Access Compliance Report Public Rights-of-Way (RR Crossings)

Intersection ID: 50272	Main Street: SOUTH_BV	Location: N/A
ADA ID: D5A460C1E127	Overall Compliance: No	Severity Score: 0.0
Codes/Mitigation Info/Possible Solution		Field Measurements/Component Compliance

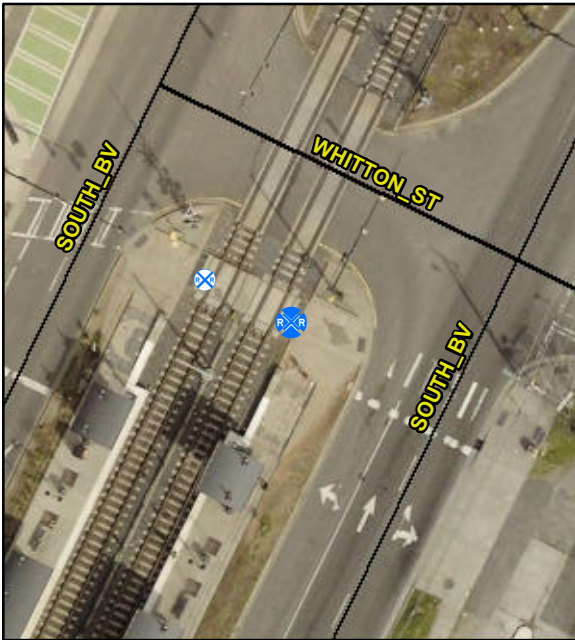
Compliance	Description	Data
Yes	DWS Provided?	Yes
Yes	DWS Contrast?	Yes
Yes	DWS Width (in)	Yes
Yes	DWS Length (in)	24.0
No	DWS Offset (in)	14.0
No	Pedestrian Gate?	No
N/A	DWS Outside Gate?	N/A
N/A	Rail Type?	LightRail
No	Flangeway Gap (in)	3.0
Yes	Sidewalk Width (in)	109.0

Remove & Replace Detectable Warning System. Provide Pedestrian Gate. Remove & Replace Walking Surface Adjacent to Rail.
